**MATANUSKA-SUSITNA BOROUGH
PLATTING BOARD
AGENDA**

JUNE 2, 2016

- A. **DENNIS BYLER** (owners/petitioners): The request is to create twelve lots and one tract from Tax Parcel B4, to be known as **WOODLAND GLADE MASTER PLAN**, containing 22.51 acres +/- . Petitioner will be constructing interior streets for access from W. Conner Court. Petitioner will also dedicate 30' wide right-of-way on the southern boundary and construct W. Dora Circle to Borough residential street standards for a distance of 223'. Petitioner is also applying for variances from MSB 43.20.140 Physical Access and MSB 43.20.060 Dedication to the public. Located within S ½ NW ¼ SE ¼ NW ¼, SW ¼ SE ¼ NW ¼, SW ¼ NE ¼ SE ¼ NW ¼, W ½ SE ¼ SE ¼ NW ¼ of Sec 35, T17N, R02W, S.M. AK, lying west of W. Lupine Lane and W. Fairview Loop. Community Council: Knik-Fairview, Assembly District: #5: Dan Mayfield

EXHIBIT A-4

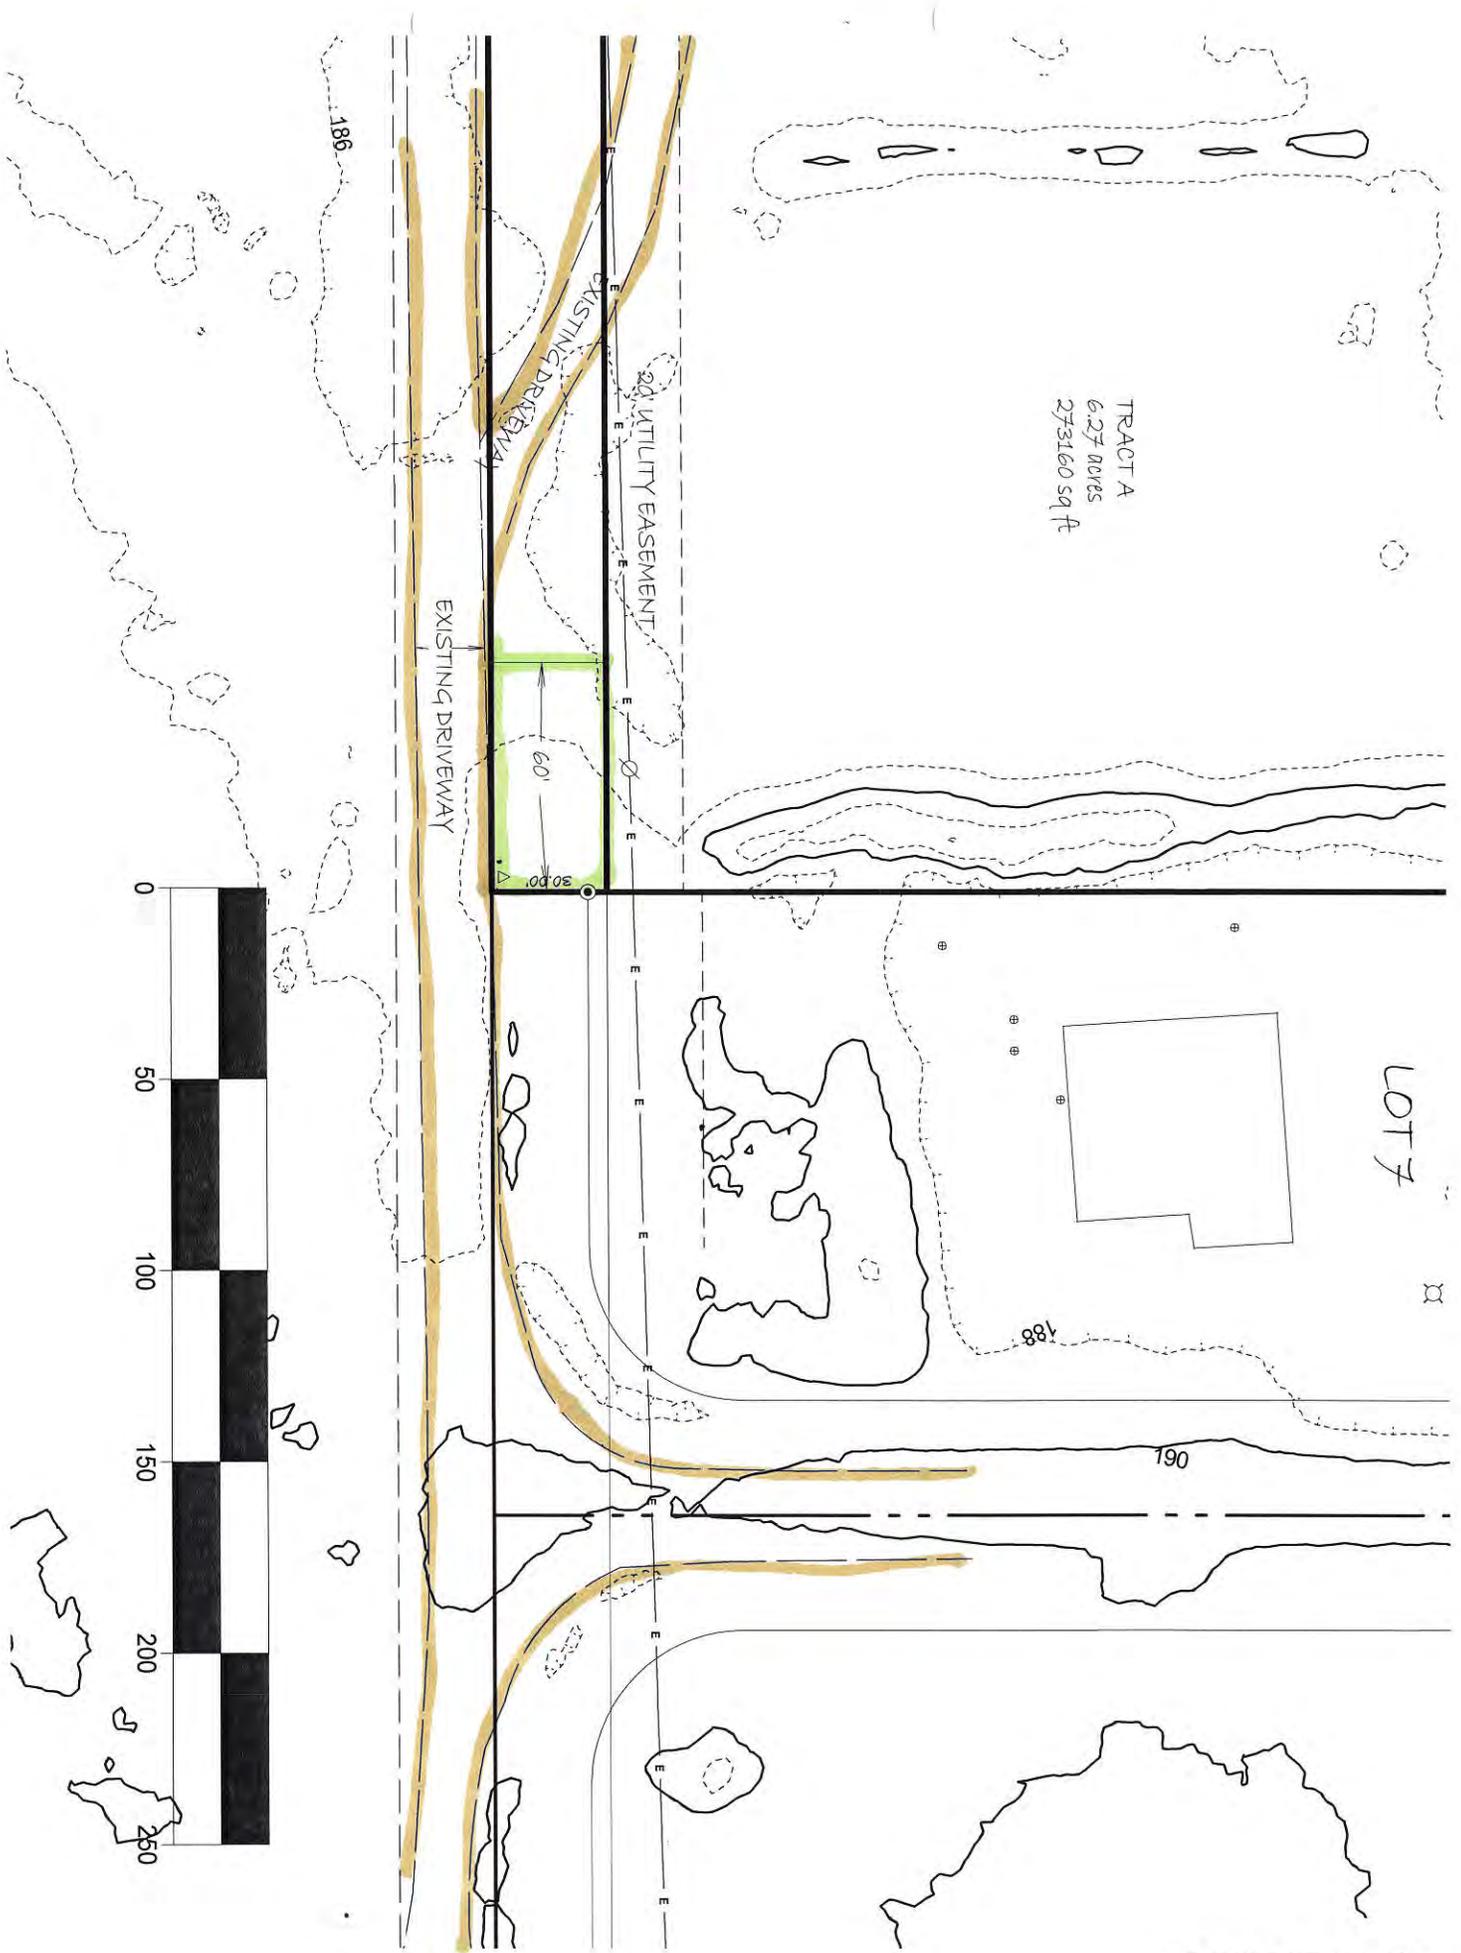
B. Typically a temporary turn around is required when there is phasing proposed (A11.1). There is no additional future development proposed for this Tract. If in the future that situation changed the applicant at that time would have to extend the road and upgrade to the required standard. This is only 23' further than what is stated in the construction manual.

C. As stated in A. above, this stub road will not change the status quo and will in fact improve upon the status quo. Were we to build a temporary turnaround it would not be providing a useful purpose and would only need to be removed in the future should the MSB decide to extend the road or if the adjoining property owner 1100 feet to the west decides to subdivide which in either case the current driveway situation would have to be changed to meet MSB specifications. In addition, there would be a conflict with existing utilities were we to construct a temporary turnaround which again would provide no improvement to what exists at the current time and would have to be removed at some future date.

OPTION #2

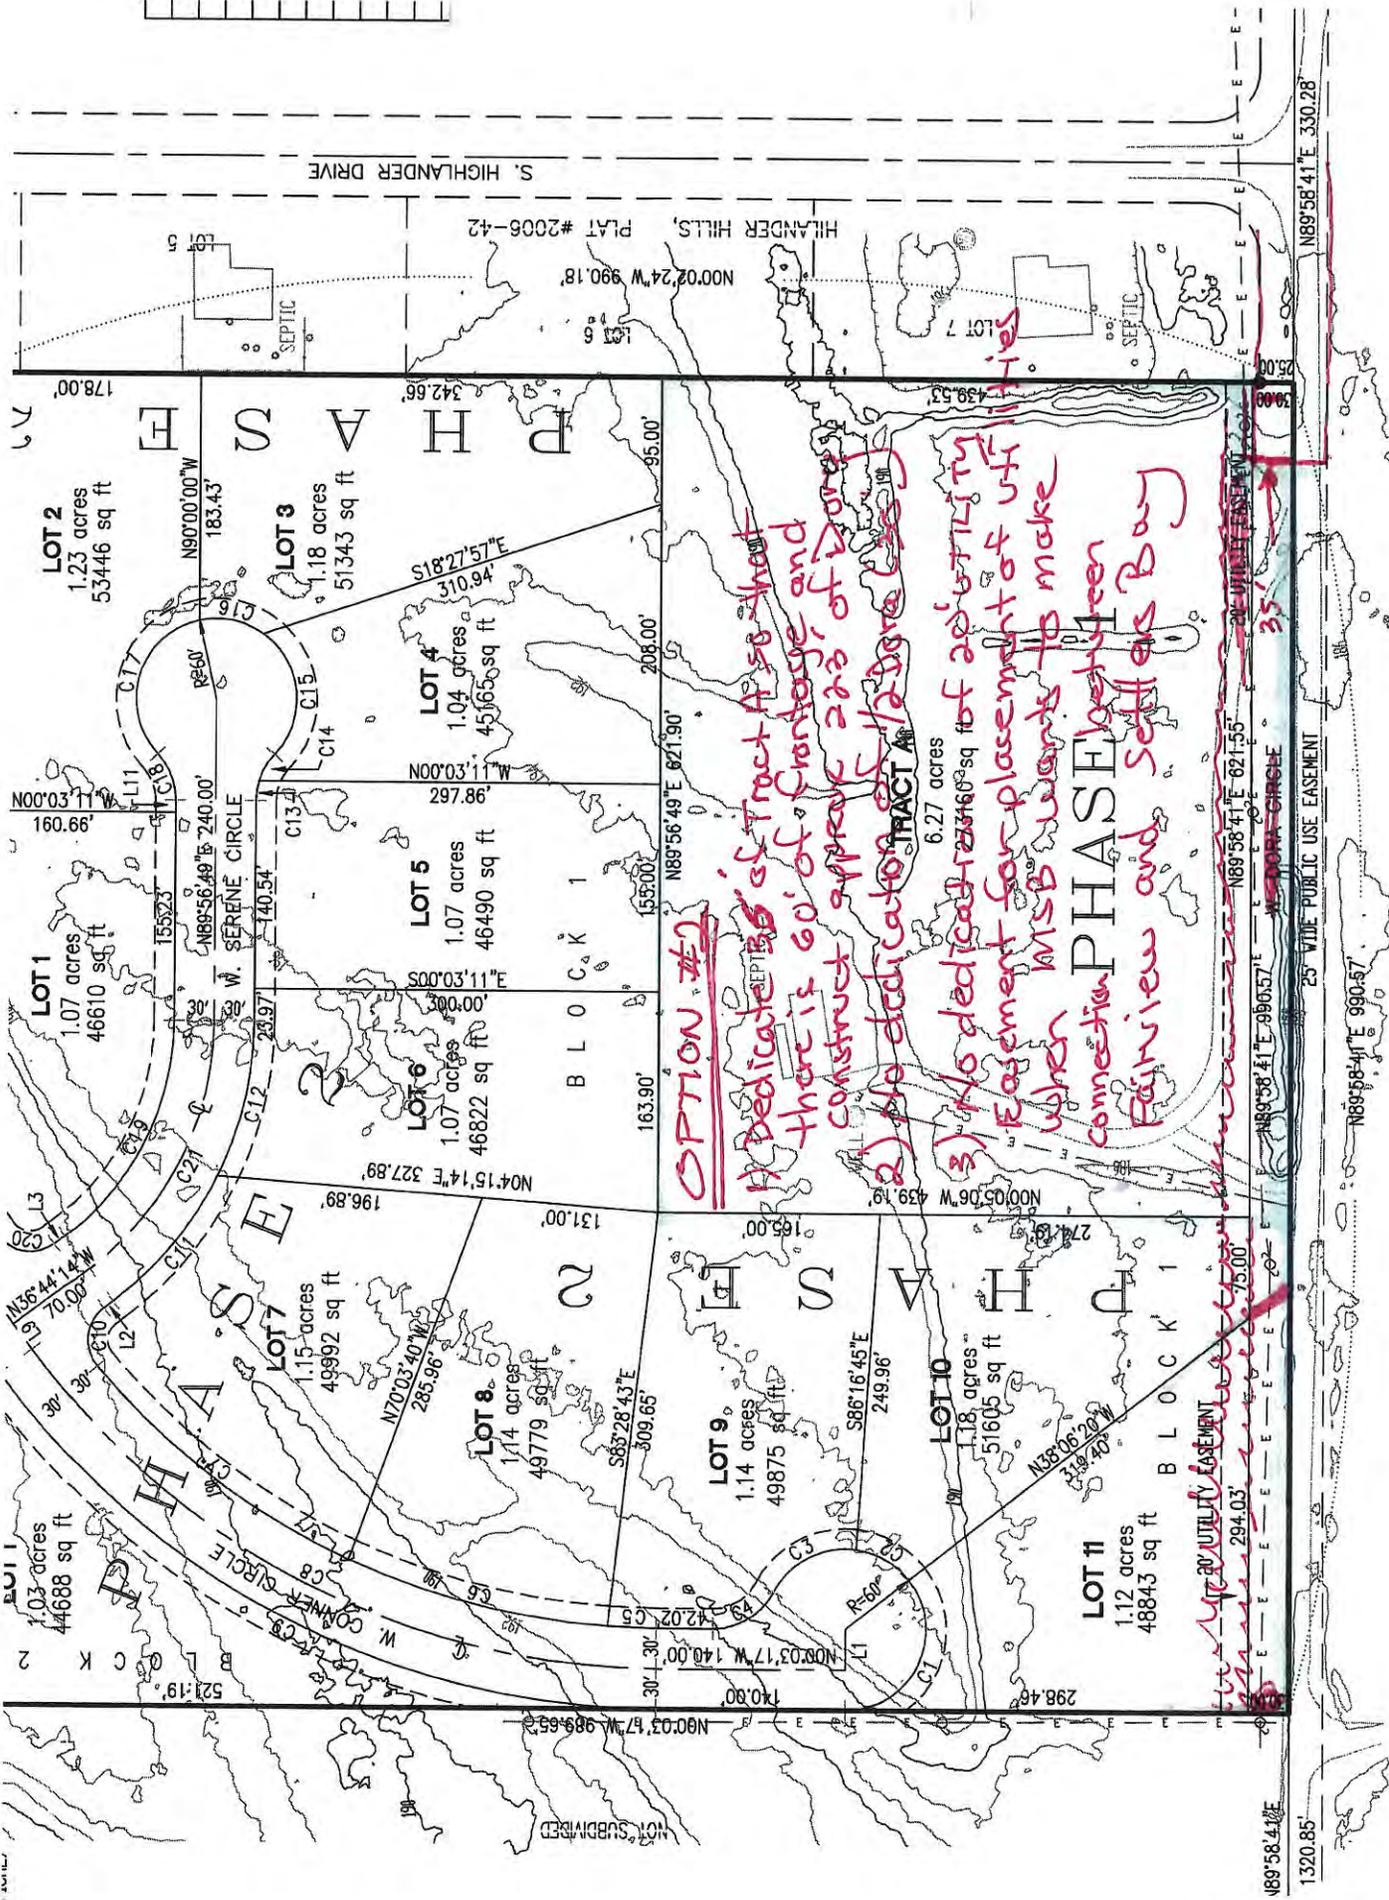
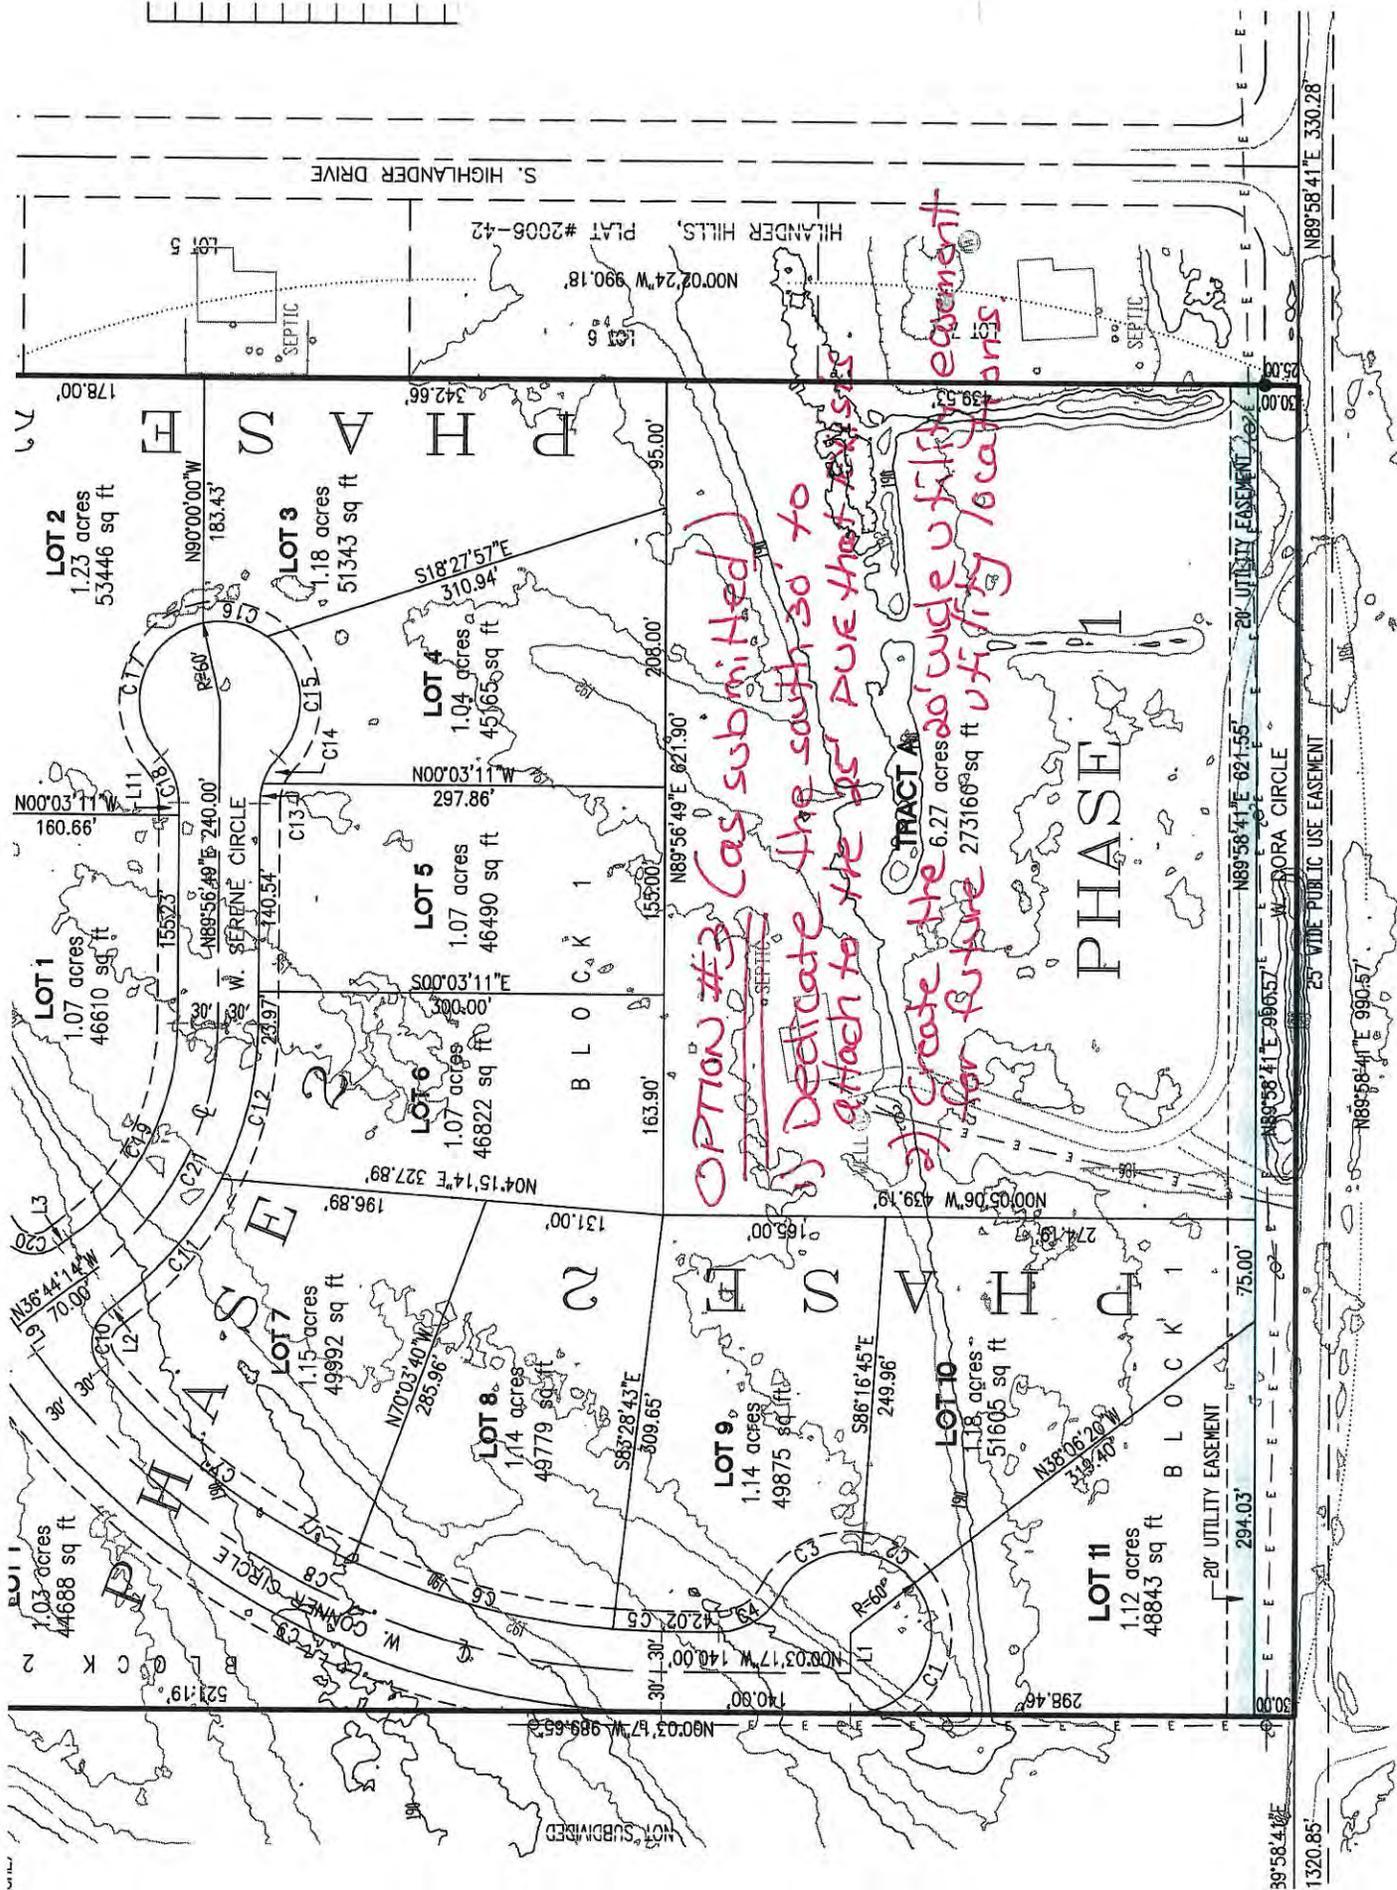
So, I have included a 4 page attachment showing various options in order to get some kind of direction in which to proceed. Either one of these options is acceptable.

- 1) Dedicated to Tract #2 so that there is 60' of frontage and construct approx 200' of 20" dia
- 2) No dedication of 1/2 acre to TRACT #1
- 3) No dedication of 27,346 sq ft of 20" utility Easement for placement of utilities when MSB wants to make connection PHASE between Fairview and Settlers Bay

OPTION #3 (as submitted)
 1) Dedicate the south 50' to attach to the 1st AVE that exists.
 2) Create the 6.27 acres 20' wide utility easement for future utility locations.
